**APPLICATION OF MANCHESTER/HEBRON AVENUE, LLC FOR
SITE PLAN APPROVAL FOR 74 RENTAL APARTMENTS AT
1199 MANCHESTER ROAD, GLASTONBURY, CT,
"BUCKINGHAM PLACE"**

Applicant's Final Set of Supplemental Materials

July 12, 2022

**RE: 1199 Manchester Road Residential Development
Glastonbury CT**

Figure S-1

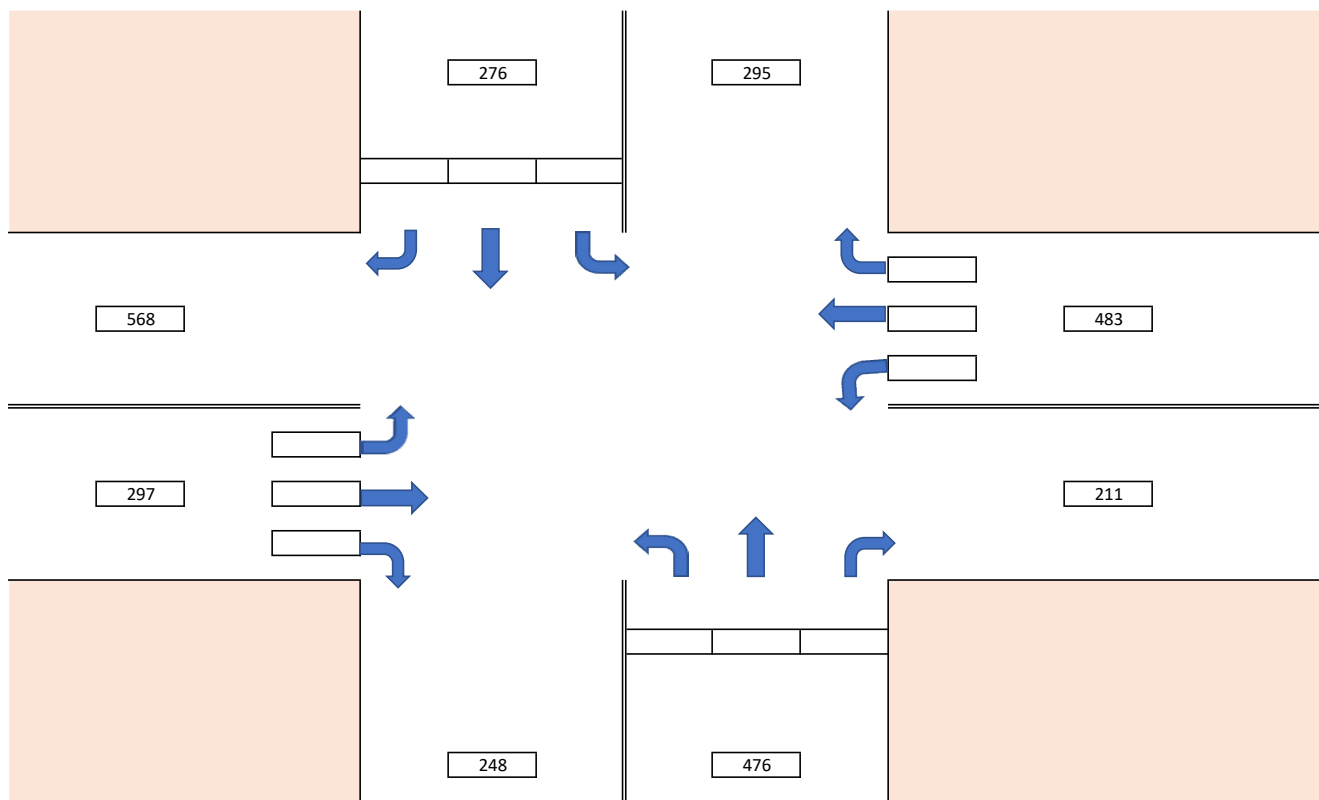
As an example, Count station 035 (the north leg of the intersection) has 2021 data showing 222 vehicles southbound and 238 vehicles northbound during the morning peak hour. The 2018 data provides only a bi-directional count of 571 vehicles. This was divided into northbound and southbound traffic using the 2021 north/south ratio, yielding 276 vehicles southbound and 295 vehicles northbound. This methodology was used for the north, east and west legs of the intersection for each peak hour. The south leg of the intersection (station 036) includes directional data, and it was not necessary to calculate the directional flows separately. The result is the target traffic volumes for each leg of the intersection, provided in Figures S-1 and S-2.

The 2022 turning movement counts were multiplied by a factor to bring them into alignment with the target 2018 counts. For the morning peak hour, all target volumes were greater than the traffic counts, so this effort expanded all of the counted turning movements.

DRAWING TITLE: **TRAFFIC CONTROL SIGNAL PLAN**

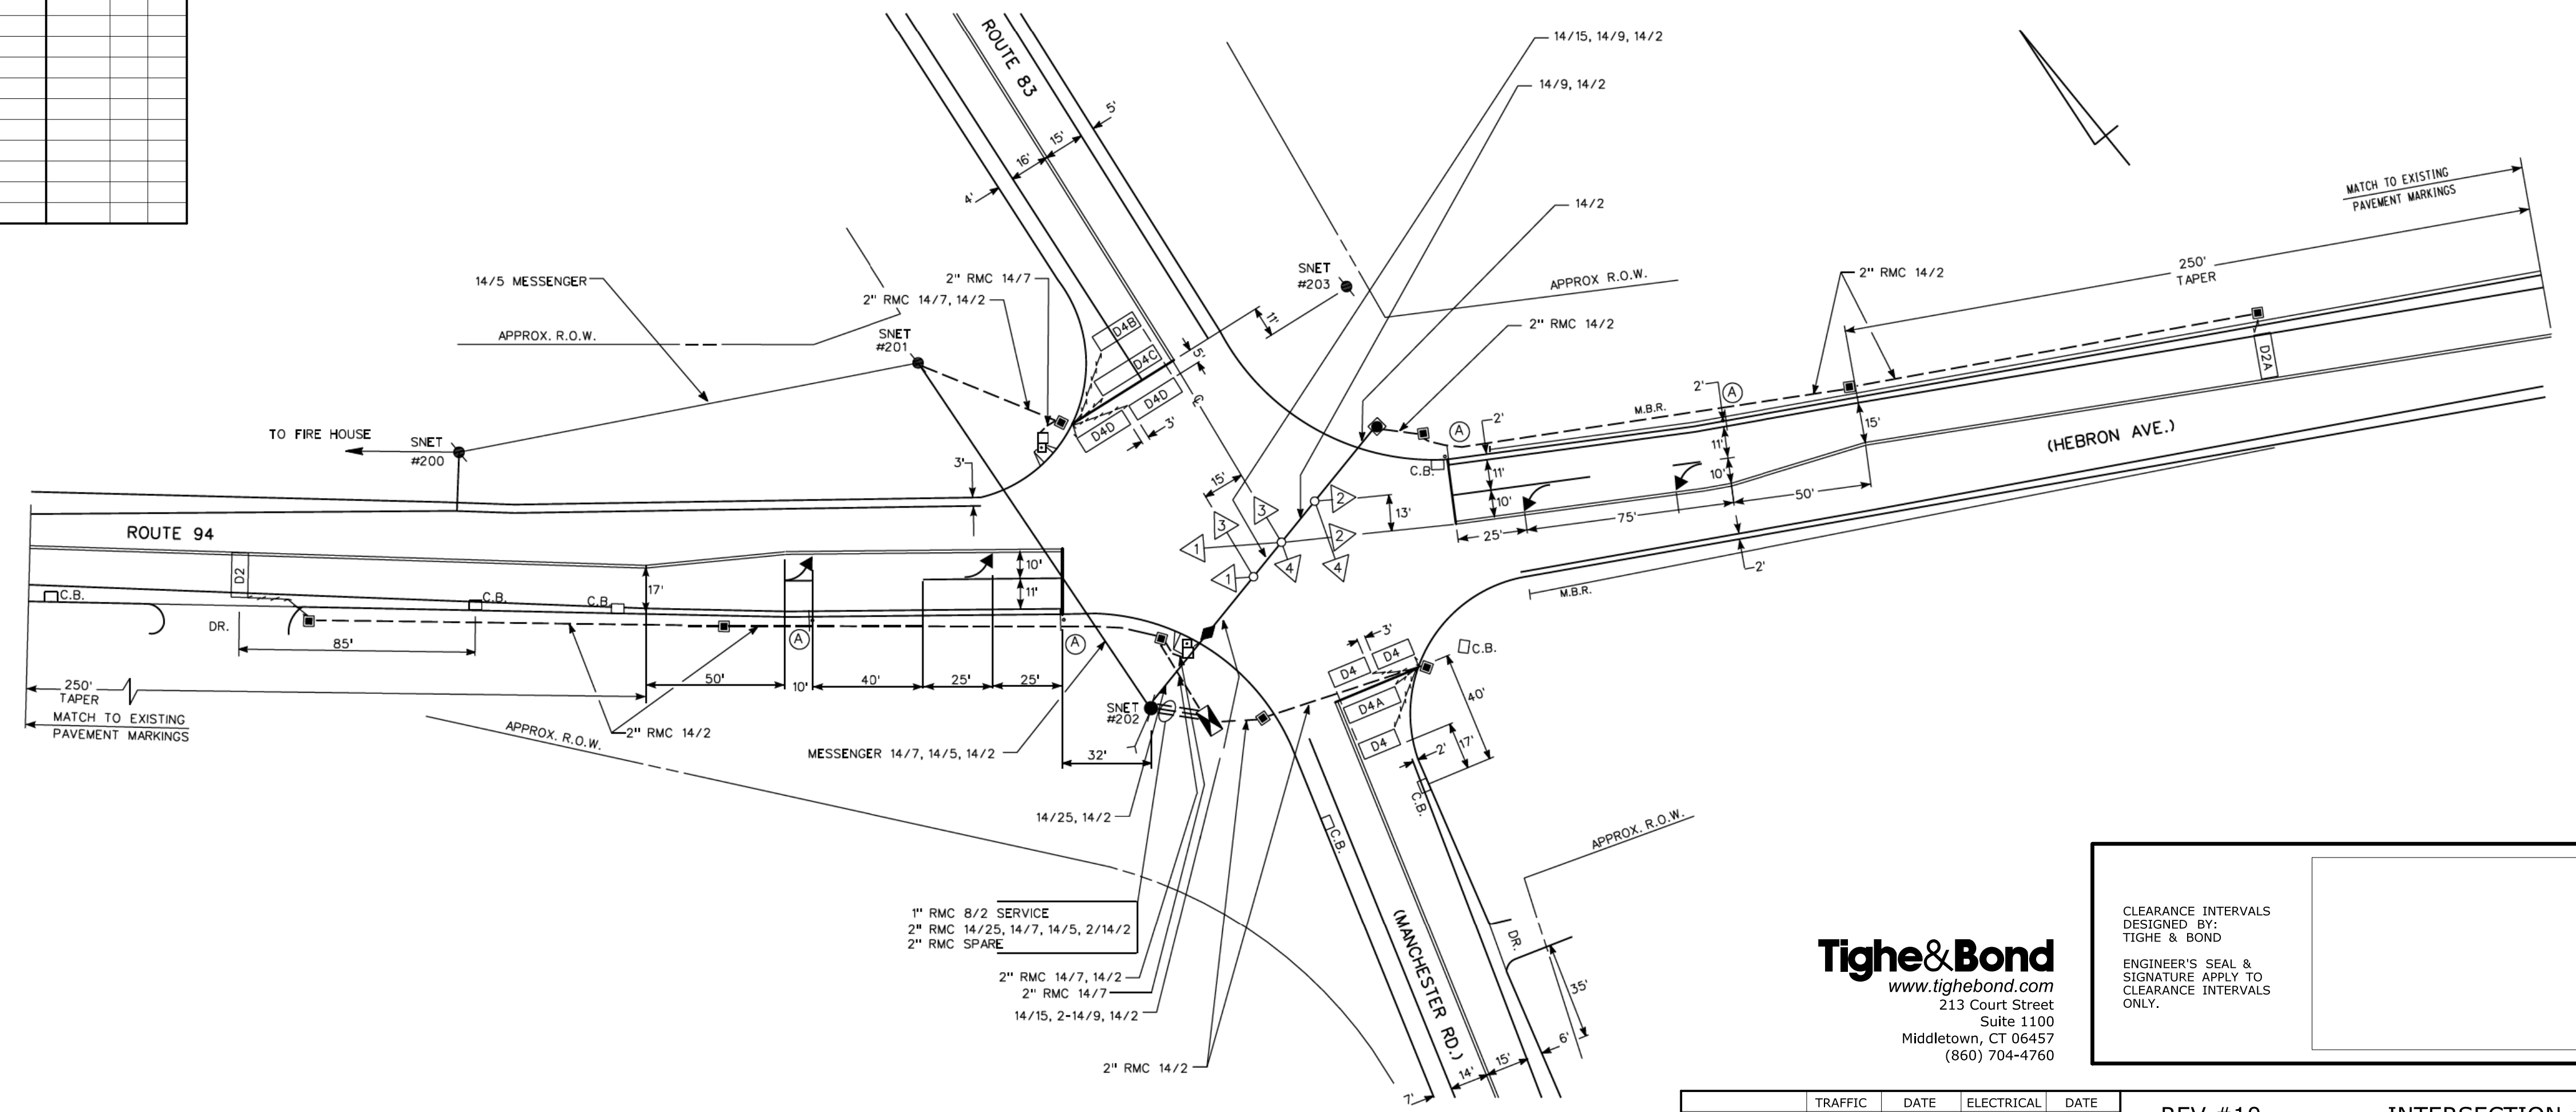
3. The Peak hour factors have been revised to reflect the counts, and as a result, a few Levels of Service have gone from A to B. However, the demonstrated impact from the development traffic is still minimal. Please note that the counts did not include truck classification, as there is no evidence that truck traffic is an issue at this location. Standard truck factors have been utilized for this analysis. The requested timing and phase inputs and vehicle queues have been included here. The CT DOT traffic control signal plan has been submitted with this letter.
